City of Houston – Code Change Proposal Form  
 Building Code Enforcement, Regulatory Affairs  
 1002 Washington Ave., Houston, TX 77002

**From:** Wierck, Heath - HPC - HPW  
**Sent:** Tuesday, May 25, 2021 1:56 PM  
**To:** Tammy Betancourt  
**Cc:** Savasta, Mark - HPC-HPW; 'Michael - HPC-HPW Howard' (Michael.Howard@houstontx.gov)  
**Subject:** FW: 3003 - HPC Response

FULLY SPRINKLERED BUILDING  
FULLY DUCTED HVAC

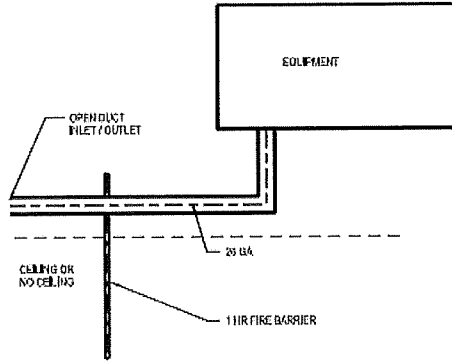
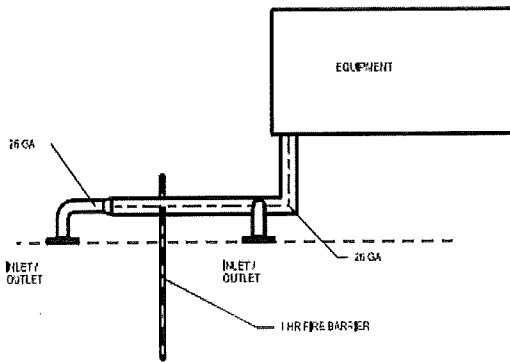
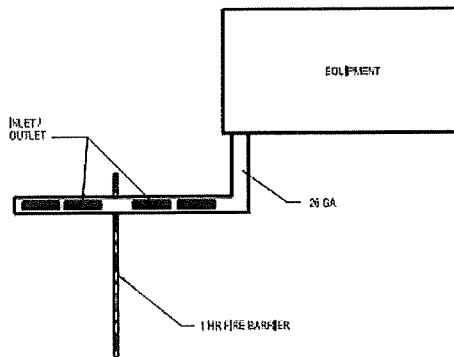
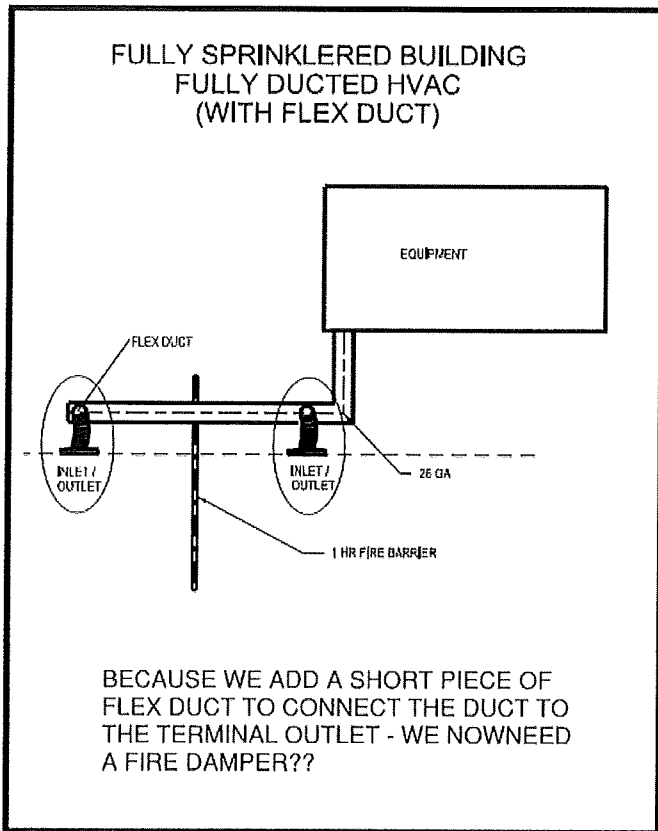
The intention of this code change is to more accurately reflect typical installations found in most buildings. As currently written, the code implies that any flex duct (or equipment flexible connections) negates the use of the exception for fire dampers in 1 hour walls in fully ducted, fully sprinklered buildings.

The code permits the omission of the fire damper for a metal duct system that terminates either at a wall (such as a sidewall grille) or continues on to a duct opening past the fire barrier and has openings in the duct ("continuous from the air-handling appliance or equipment to the air outlet and inlet terminals"). This section does not prohibit openings to be on both sides of the duct as long as the openings are in metal duct. However, as currently written, if flex duct is used to connect a metal duct to a ceiling diffuser (standard practice) this triggers the requirement for a fire damper.

Likewise, a flex connection at the AHU within the mechanical space does not constitute a hazard that should trigger the fire damper within the system

As proposed, this section will coordinate with the requirements already established in the International Mechanical Code. IMC Section 606.6.3 limits the design air temperature for flexible air connectors to 250 degrees F (121 C). Under the vast majority of conditions where flexible air connectors will be used (installed above a ceiling, light or ordinary hazard occupancy, ordinary or intermediate temperature sprinklers, quick or standard response), the sprinkler response can be demonstrated by calculation to occur before the ceiling jet temperature from a fire reaches the limit of 606.6.3.

ALL FIRE DAMPERS  
**NOT ACCEPTABLE**

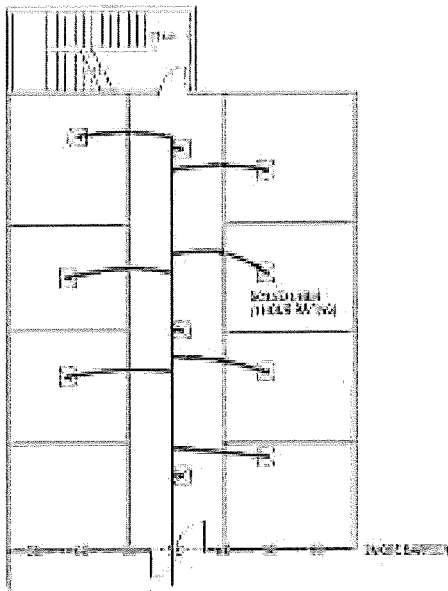
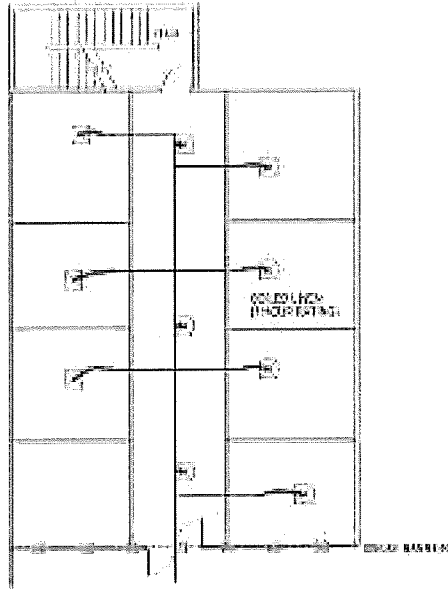
It is not the intention of the code change to allow flexible ducts through any vertical barriers (as already prohibited by Section 717.7). The flexible ductwork is only to be allowed within a room, and above the ceiling. See the sketch below to better clarify the intention.

## PROPOSED CODE

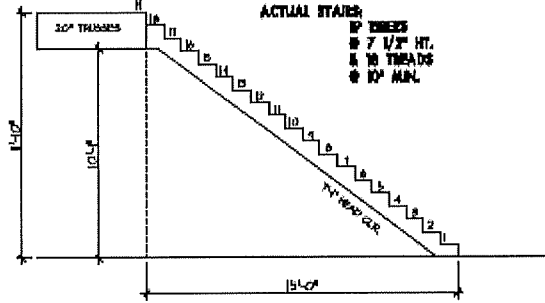
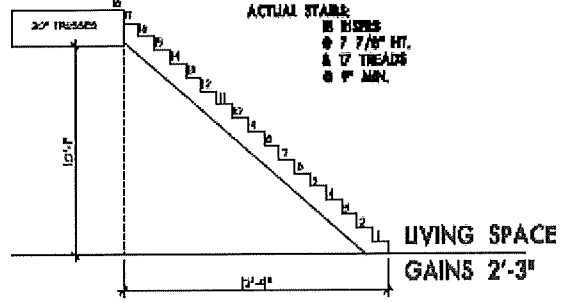
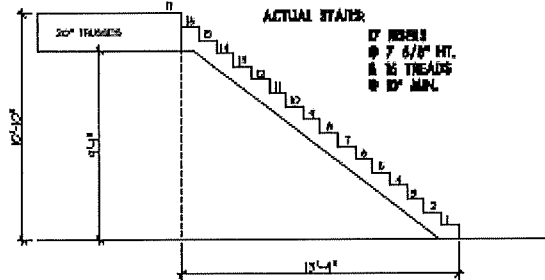
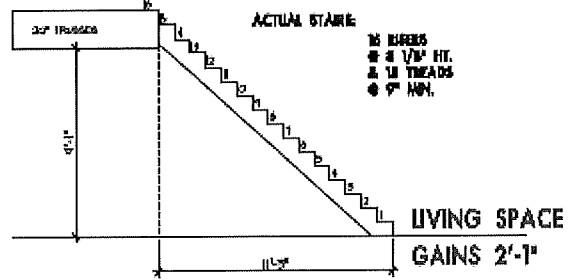
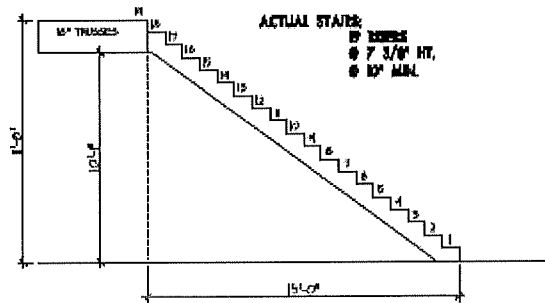
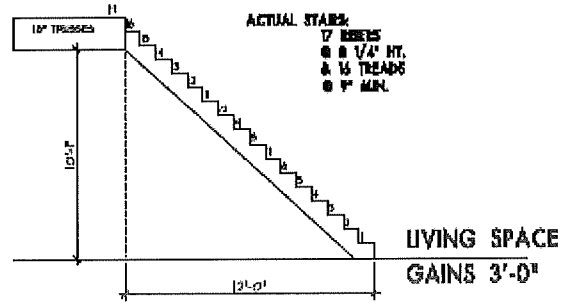
As outlined in Section R101.3 of the IRC, the code is to provide minimum requirements for occupant safety and health. There is adequate substantiation to show that 8¼-inch x 9 inch geometry provides this minimum level of occupant safety.

The language proposed herein by allowing increased design and construction flexibility also specifically caters to our unique local conditions where housing is at a shortage, costs have dramatically increased, and developable, affordable lots are scarce.

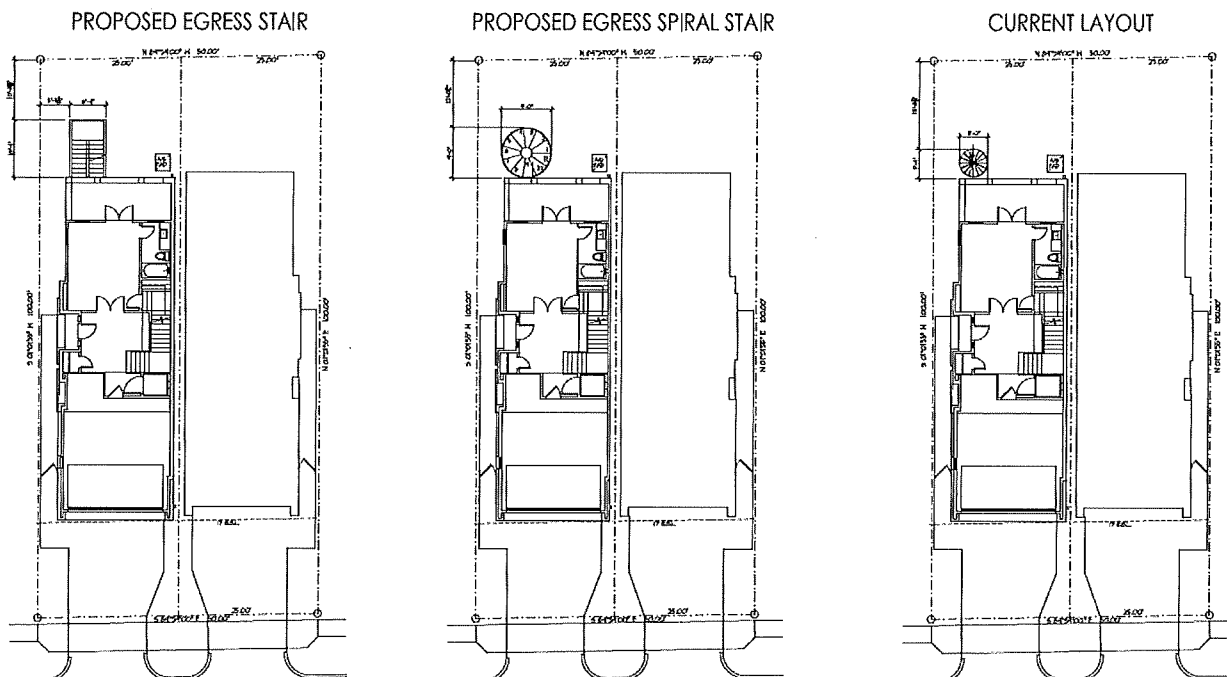
This is the second proposal for striking the above proposed City of Houston amendment.

Our original justification was based on the interpretation that this was bring applied to “Stairs, Ramps, Doors, and Landings” of “Accessory Structures”. In our meeting with BCE, it was explained that this was to be interpreted and enforced on all stairs, landings, and ramps unless specifically addressed elsewhere in the code. How would this be applied to non-egress related doors, such as closet door landings, bathroom doors landings, pantry door landings, etc.? This is infeasible in many remodel situations and wouldn’t make sense for new construction. IBC also makes allowances for ramps which are not used as a means of egress, so why wouldn’t similar provisions be made here? Why expand these requirements to all stairs, ramps, and landings on the property?

Comments: HPC recognizes and appreciates the work and recommendations submitted by Mr. Williams and the CIC organization. The request to remove Houston amendment R311.1.2 for Accessory Stairs, Ramps, and Landings has been denied. It was previously agreed by the Code Development Committee that "doors" would be removed from the

section due to the provisions of R311.2 governing. The Committee continues to believe that accessory stairs, ramps, and landings in residential structures should be constructed as prescriptively detailed in the code to increase the safety for those same types of elements when they're not part of the means of egress system. This is not a change to construction in Houston as historically this has always been the practice. This amendment will aid the reader in knowing the intent and expectations for appropriate code established standardized dimensions and structural requirements for these types of structures.
